UNITED STATES  
NUCLEAR REGULATORY COMMISSION  
REGION I  
631 PARK AVENUE  
KING OF PRUSSIA, PENNSYLVANIA 19406

April 8, 1982

SUBJECT: ONCE THROUGH STEAM GENERATOR (OTSG) EDDY  
CURRENT INSERVICE INSPECTION

**TMI-1 Tube Sheet  
Detail (Typ.)**

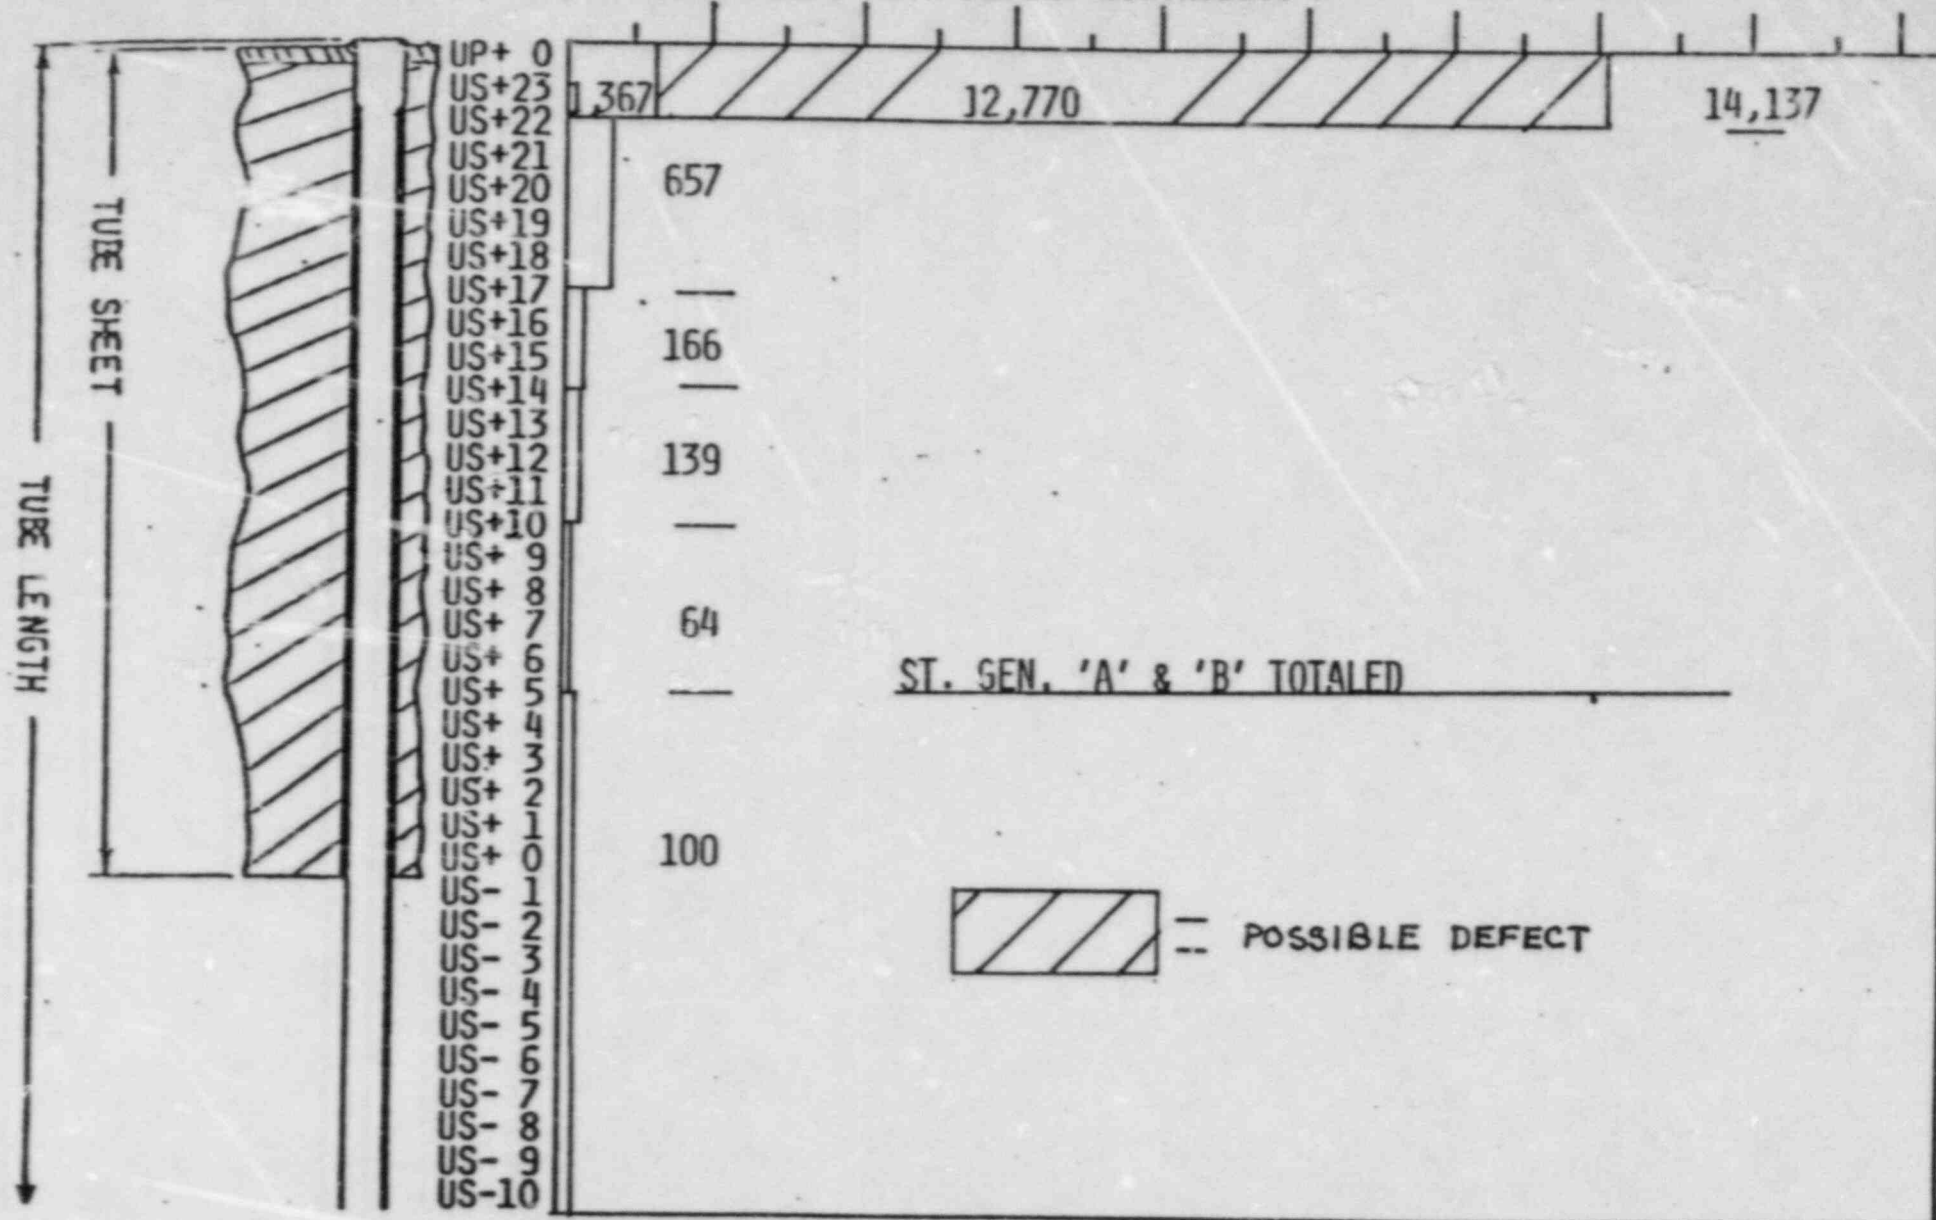
- \*1. (1) TMI Unit 1 Technical Specifications requires that only the area between the lower face of the upper tube sheet and upper face of the lower tube sheet be inspected using standard eddy current testing. Ninety percent of the tube problems found in Unit 1 OTSG's are in the area known as the roll transition in the upper tube sheet (see Attachment 1 and 2). Due to the definition eddy current testing requirement which is standard throughout the industry, the area in question is not addressed in the Technical Specifications (see Attachment 3). In the inspector's judgement this concern should be evaluated to determine if OTSG eddy current program should be redefined and amendment made to Technical Specifications.

- (2) With the use of a standard differential eddy current probe (industry standard), a signal deflection is normally generated in the roll transition zone. This signal from roll transition zone is normally ignored due to the inability of the standard probe to distinguish between roll and/or a fault. In the case of TMI-1, the licensee did take the time to look at this area. GPU with the aid of Conam (Eddy Current Contractor) and Zetec (Eddy Current Vendor) developed a new probe commonly known as 4 by 1 absolute pancake probe. This probe has been very successful in determining faults in the transition zone as compared to metallurgical data obtained. In the inspector's judgement, the roll transition zone is normally overlooked by the standard probe and due to the severity of the problem at TMI-1, this item should be evaluated for its safety significance (see Attachment 4 and 5).
